LAKE CHOCTAW DAM

NDS ID NO. PA-00819

PHASE I INSPECTION REPORT

NATIONAL DAM INSPECTION PROGRAM

A. Upstream Slope of Embankment.

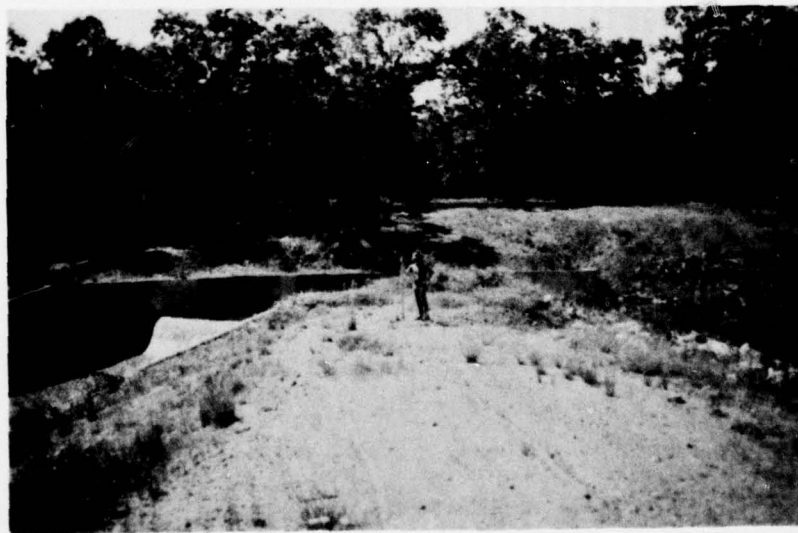
(3) Over a 15-foot long reach, located about 25 feet left of the spillway, the embankment was not to design template. The riprap was not to top of dam, the width of top of embankment was less than design width, and the upstream slope was about 2 feet below design template (Photograph B). Along the rest of the upstream slope the riprap was intact and continuous to the top of the dam. Some light brush was growing among the riprap (Photograph A).

(3) Where the riprap is missing and the upstream slope is below design slope, erosion of the embankment could occur during periods of large spillway discharge or by wave action. The light brush growing among the riprap is undesirable.

(1) Repair area on upstream slope of embankment near spillway.

(3) Remove brush growing among riprap on upstream slope.

C. Downstream Slope of Embankment with  
Spillway Chute in Foreground.

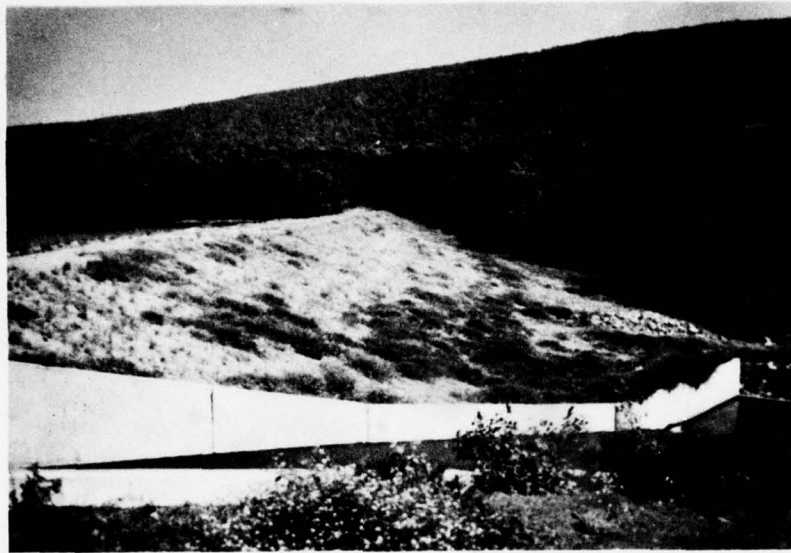
(4) The top and downstream slope of the embankment did not have a good cover of vegetation (Photographs A, B, C, and D). Some minor erosion gullies, which were less than 1 foot deep, were visible on the downstream slope. Crownvetch was planted on the downstream slope (Photographs C and D), but it covers only about 25 percent of the slope.

(4) The existing erosion gullies on the downstream slope of the embankment are not large enough to require filling. However, because the cover on the downstream slope is not well established, there is a potential for deepening of the gullies or development of new ones.

J. Wet Area at Toe of Embankment  
200 Feet from Left Abutment.

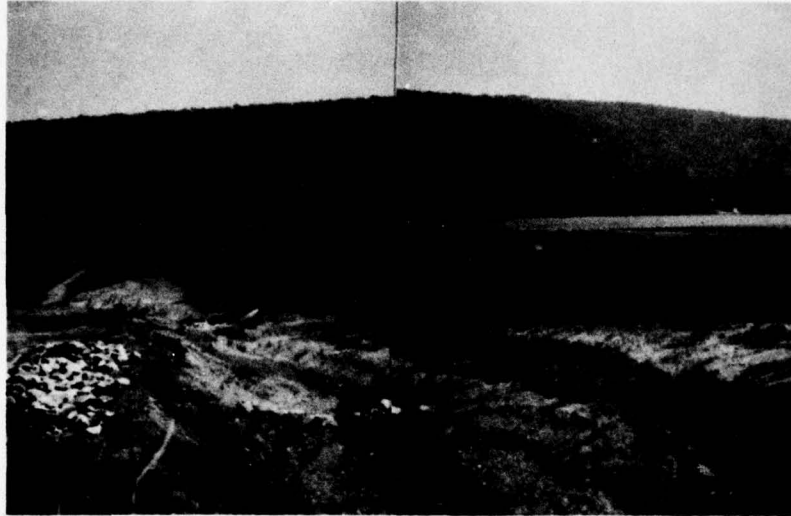
(5) A wet area was located along the downstream toe of the embankment about 200 feet from the left abutment (Photograph J). A slight amount of standing water was visible, but no flow was observed. The area was not particularly soft, and it appeared that the probable source was surface runoff.

(5) The two wet areas along the downstream toe of the embankment appear to be the result of surface runoff. However, the wet areas are in the vicinity where Northeastern Engineering Company encountered springs during the investigation of the site. If springs should develop, the stability of the embankment could be affected. Consequently, any unusual conditions along the toe in this area are of general concern.

(5) Visually monitor the two wet areas along the downstream toe of the dam. The outflow should be estimated and records should be kept so that any change in condition is apparent.
